## Vesting Tentative Tract No. 67505 Project

Environmental Case: ENV-2005-2301-EIR  
State Clearinghouse No.: 2005111054

**Project Location:** 22255 and 22241 W. Mulholland Drive, Los Angeles, CA 91364

Figure 1  
Fuel Modification Buffer Area Map

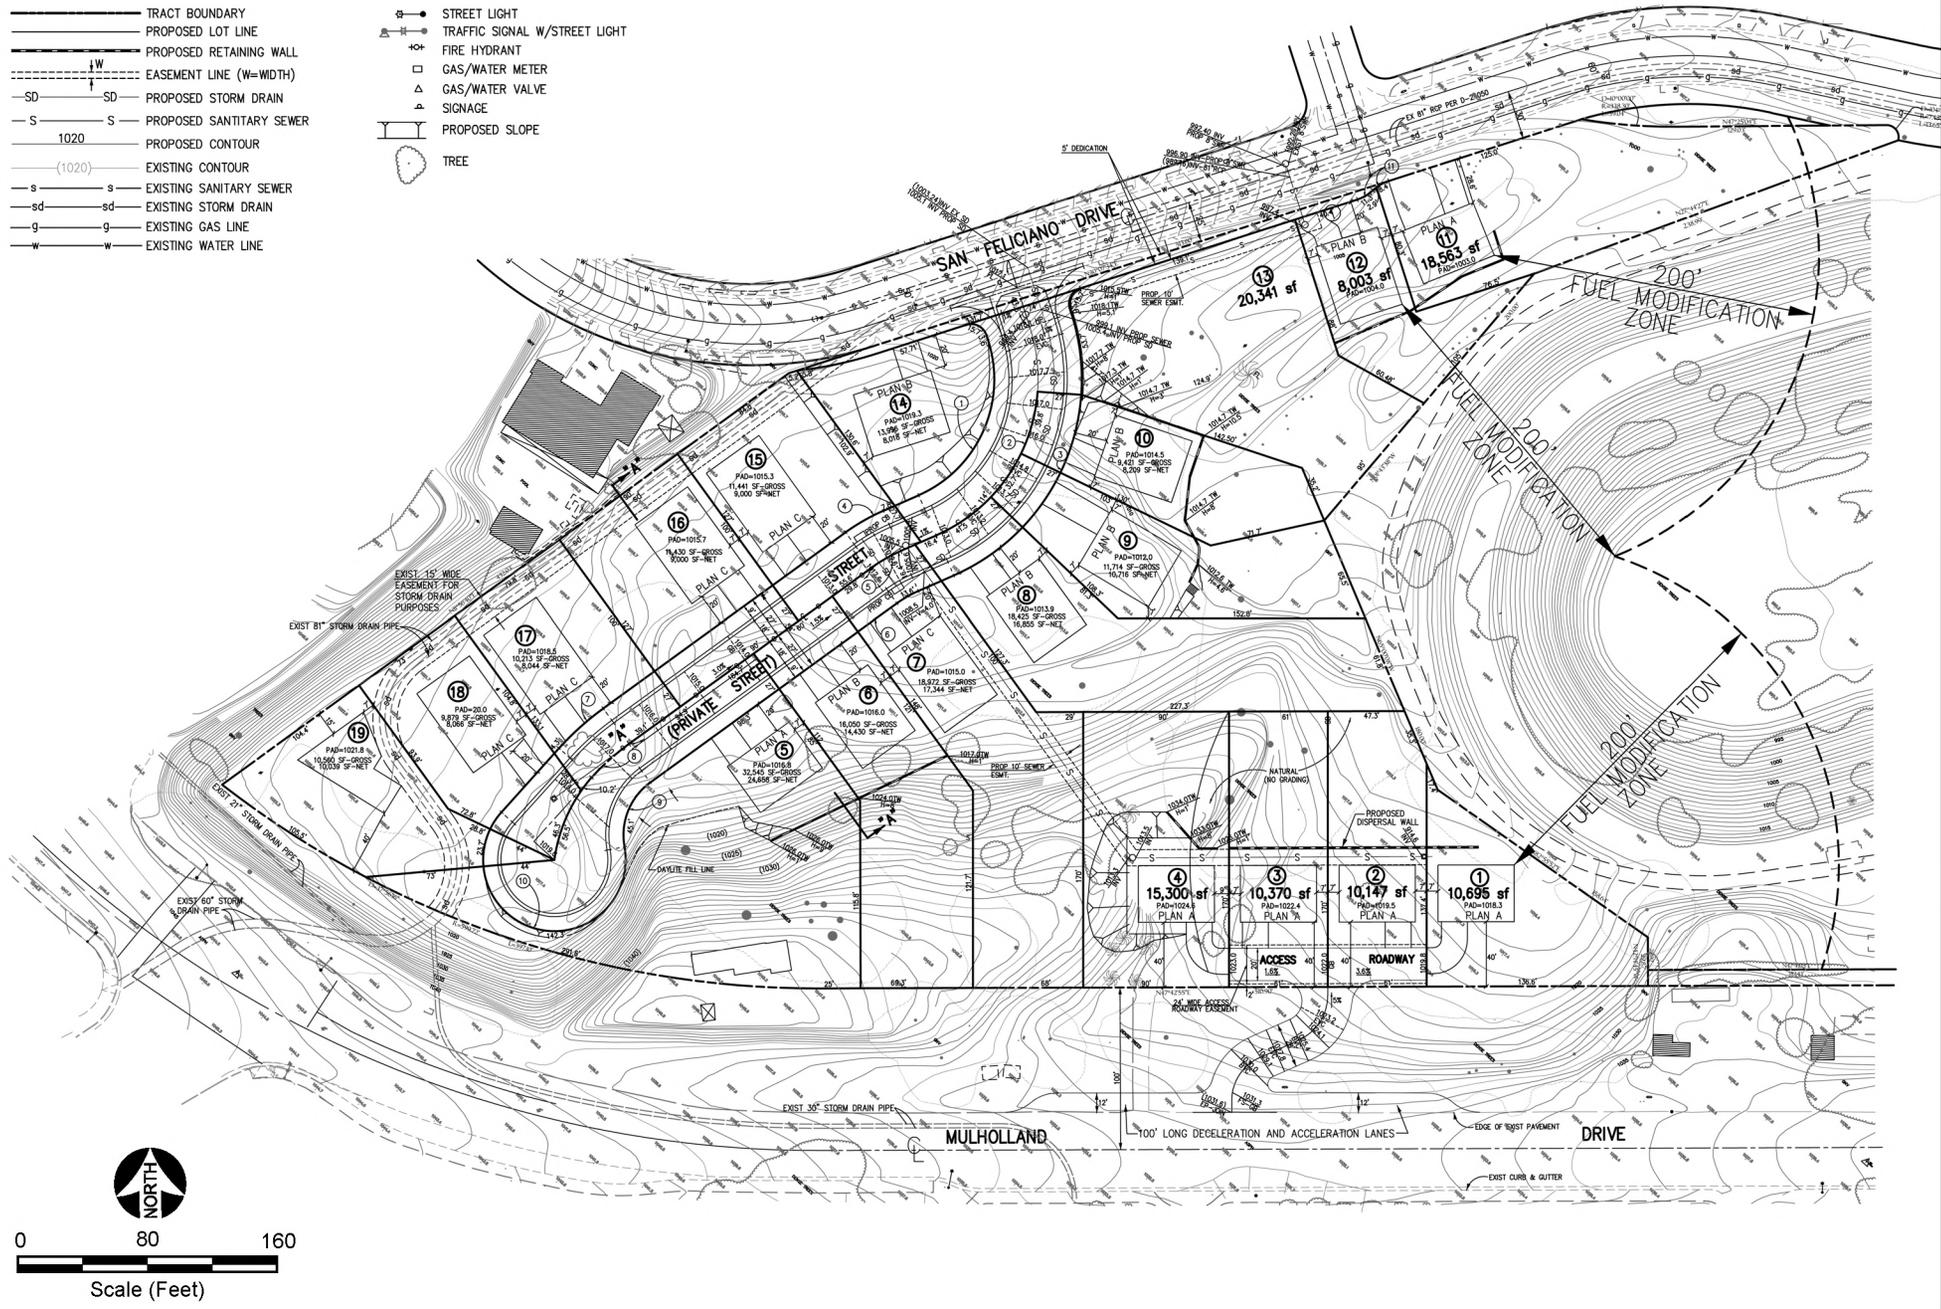
#### **Comment No. A3-7**

The Project Site would continue to be subject to brush clearance/weed abatement required by the City of Los Angeles Fire Department. The Project Site has been maintained in approximately the same fashion and subject to brush clearance requirements for many decades. Brush clearance activities conducted in the last few years were monitored by a biologist in order to avoid direct impacts to wildlife. To the extent practicable, native shrubs were retained and weedy non-native species were removed. Following Project development, fuel modification activities would be required within 200 feet of the proposed homes within the Project Site as well. Some of this work would extend onto the western portion of the DWP reservoir

property, as shown on Figure 1, Fuel Modification Buffer Area Map. Fuel modification activities required within 100 feet of the proposed structures would only require the trimming of trees and brush and the mowing of other vegetation along the western berm of the reservoir and within the open space area on-site. The Los Angeles Fire Department (LAFD) requires that areas within 100 feet of the proposed structures be irrigated and managed. Fuel modification actions required between 100 and 200 feet of the proposed structures would only require trimming of trees within the western portion of the reservoir itself as well as on portions of the on-site open space area. The trimming of trees and mowing of other vegetation would not significantly impact the protected trees either on-site or on the DWP property, nor would these activities result in any significant visual impact.

Fuel modification activities would be required within 200 feet of the proposed residential structures on the Project Site, an area that would include the western portion of the LADWP site. Fuel modification activities required within 100 feet of structures would only require trimming of trees and brush and mowing of other vegetation along the western berm of the reservoir. Fuel modification activities required within 200 feet of structures (but more than 100 feet from the structures) would only require trimming of trees within the western portion of the reservoir itself. These fuel modification activities, however, would not result in significant impacts to sensitive species (see previous discussion), wetlands (no excavation, hydrologic modification, or placement of fill material would be required), or protected trees (tree trimming is not prohibited under the City's Protected Tree Ordinance or the Mulholland Scenic Corridor Specific Plan).

Figure 2  
Stopping Sight Distance Analysis

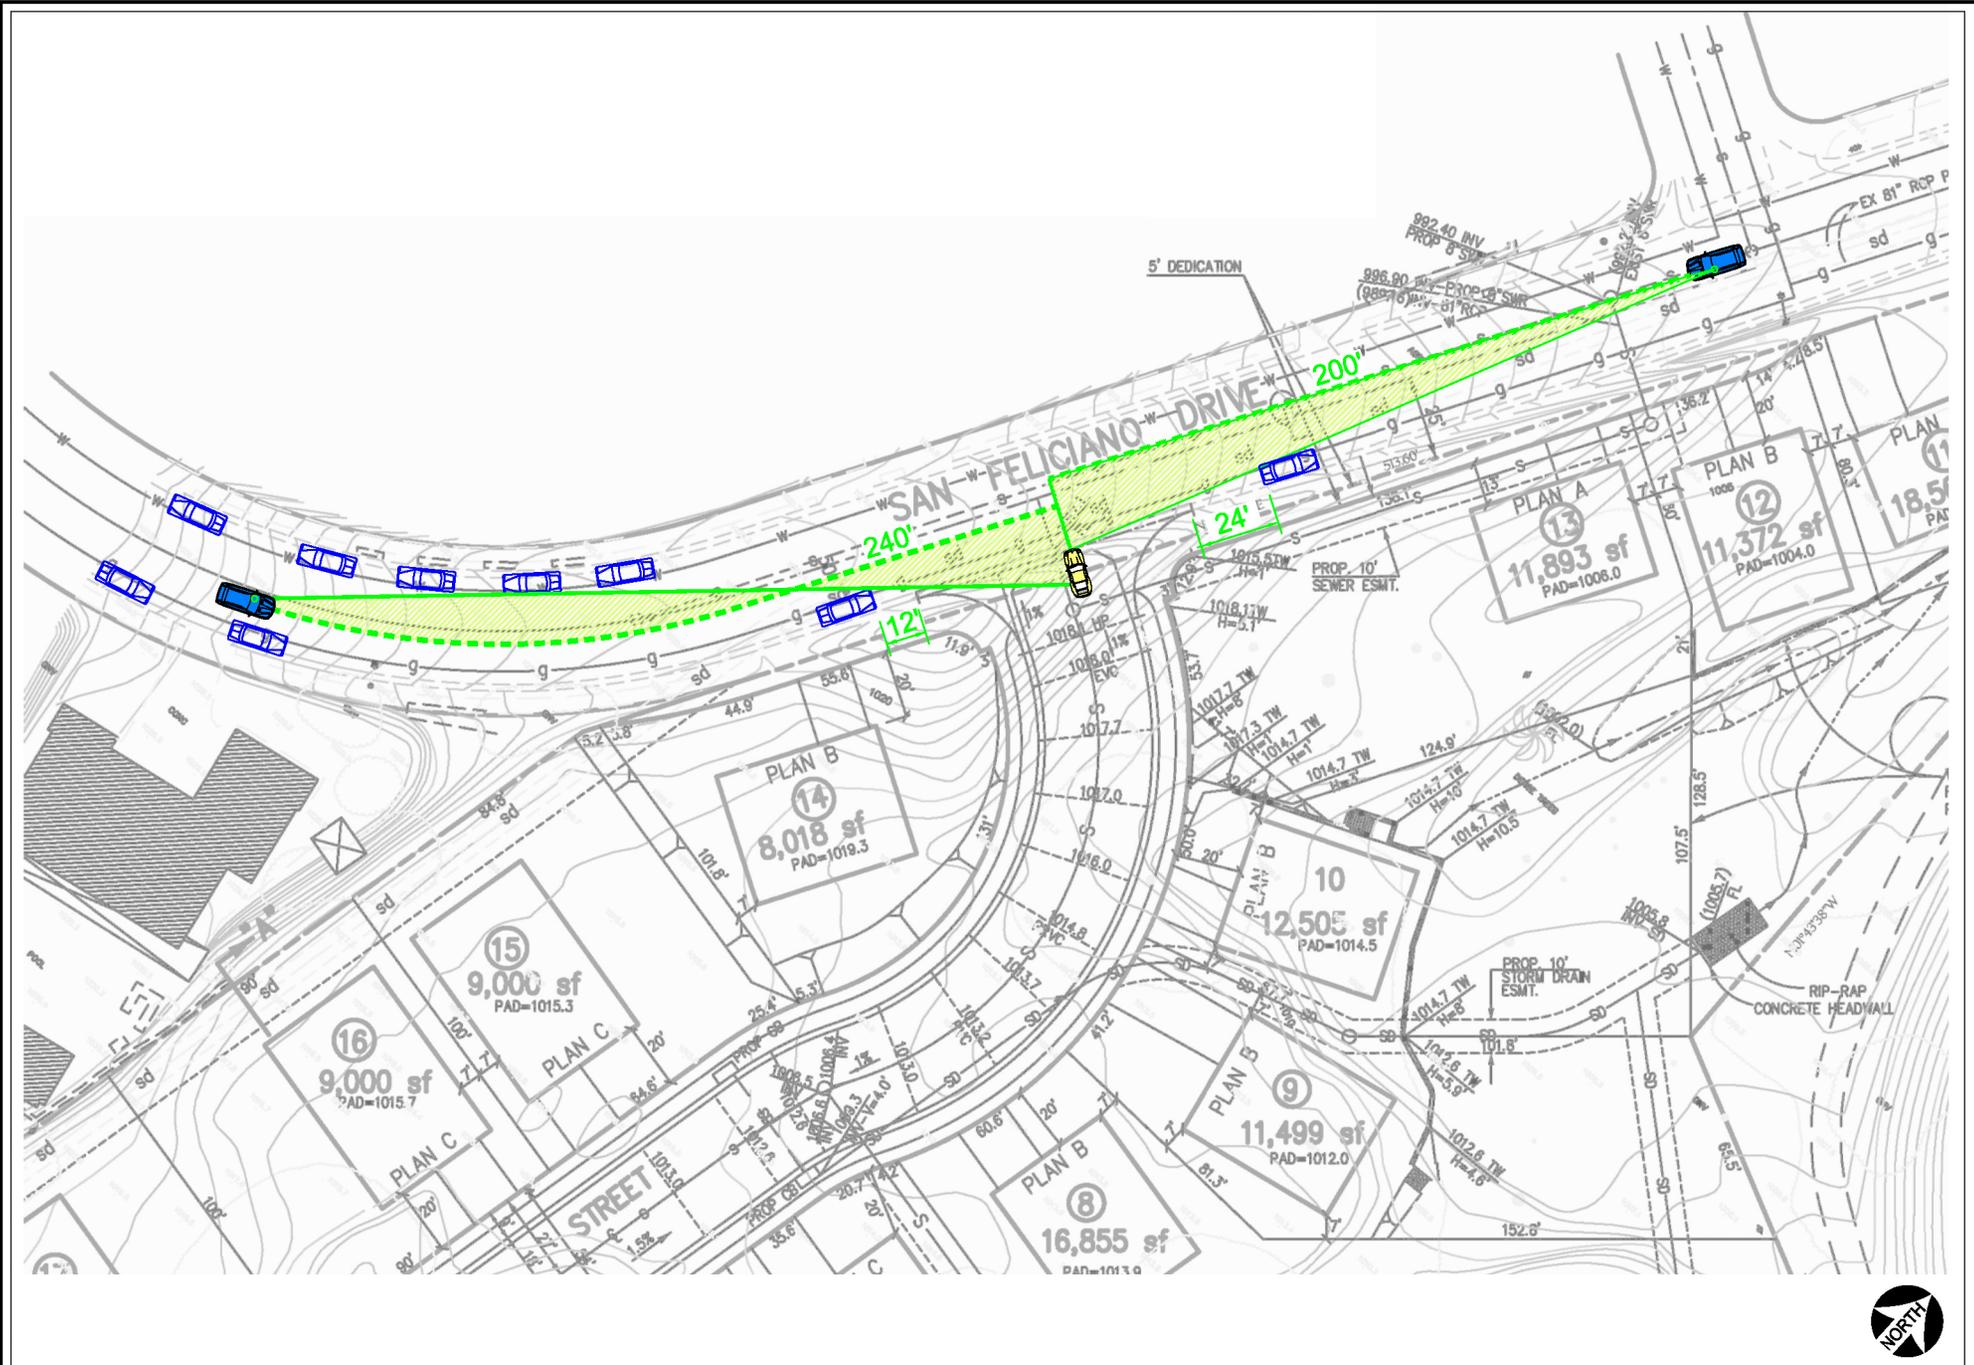
Below – looking West from Cerillos to San Feliciano Dr. where at least two driveways would spill out into the intersection. In addition, please note solid row of Oak trees lining the street that would have to be removed to make way for lots 11-13.

See Pic

As shown in Figure 2, Stopping Sight Distance Analysis, with cars parked in the legal parking spaces where they most impact sight distance, a vehicle entering San Feliciano Drive from the Project roadway would have 240 feet of sight distance. This sight distance is in excess of the AASHTO "A Policy on Geometric Design of Highways and Streets" minimum standard of 211 feet for the legal posted speed limit of 30 MPH and grade of 5 percent. It should be noted that the sight distance analysis was conservatively based on the San Feliciano driver seeing the Project exiting vehicle while it was at the stop line rather than the entering vehicle pulling forward. The braking distance estimate was also based on the full site distance grade rather than the flatter grade within approximately 111 feet of the intersection where braking would occur.
